# SERVICE No. 1026 BULLETIN

Distribution of Parker Hannifin Airborne Service Letter 48, "Inspection/Replacement of dry air pump flexible couplings".

**Service Letter Number:** 48

**Subject:** Inspection/Replacement of dry air pump flexible couplings.

**FIGURE 1**

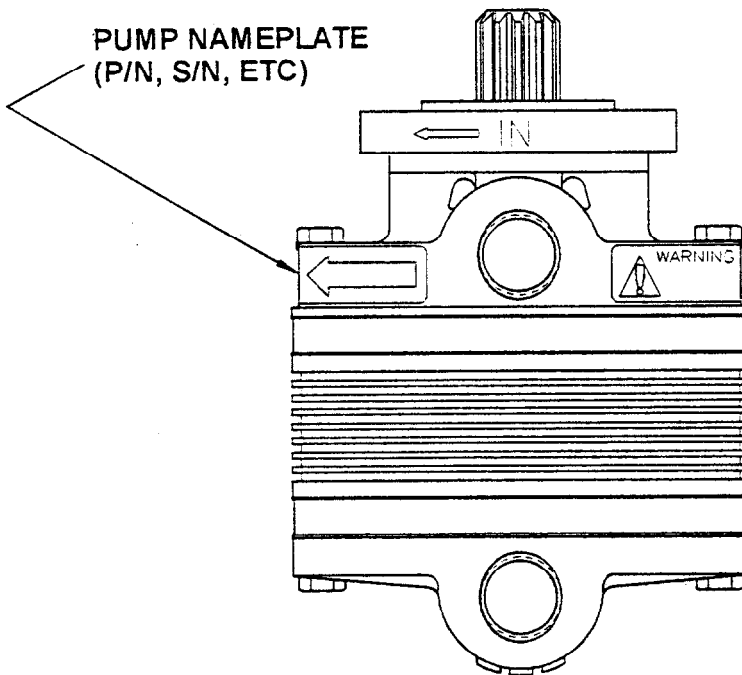
**Applicability:** Airborne dry air pumps, conversion kits and flexible coupling kits with the following part numbers/serial numbers which have not been inspected per this service letter as identified in step number seven of the procedure listed below. These components were shipped from Airborne between 1/1/98 and 10/13/98. Refer to Figure 1 for location of part number/serial number nameplate.

FIGURE 2

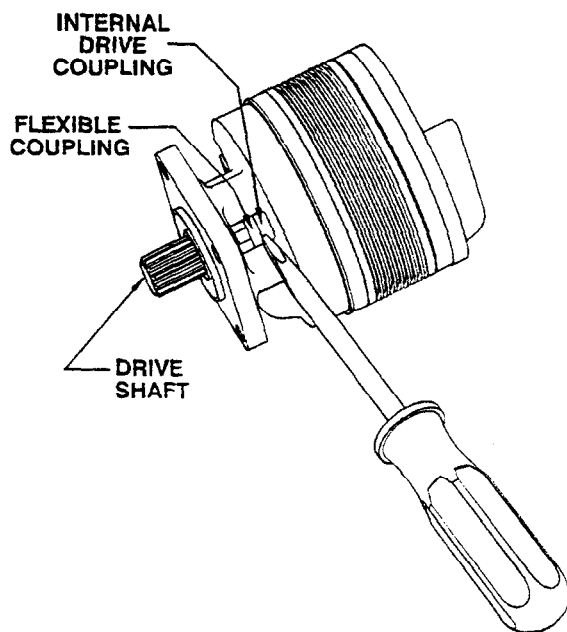
- 1) Remove dry air pump from engine accessory pad per instructions provided by the airframe manufacturer in the appropriate maintenance publication.
- 2) Insert a screwdriver or similar tool between the flexible coupling assembly (2-piece) and the pump's internal drive coupling. Remove the flexible coupling assembly from pump, taking care not to damage any of the eight drive pins. Refer to Figure 2.
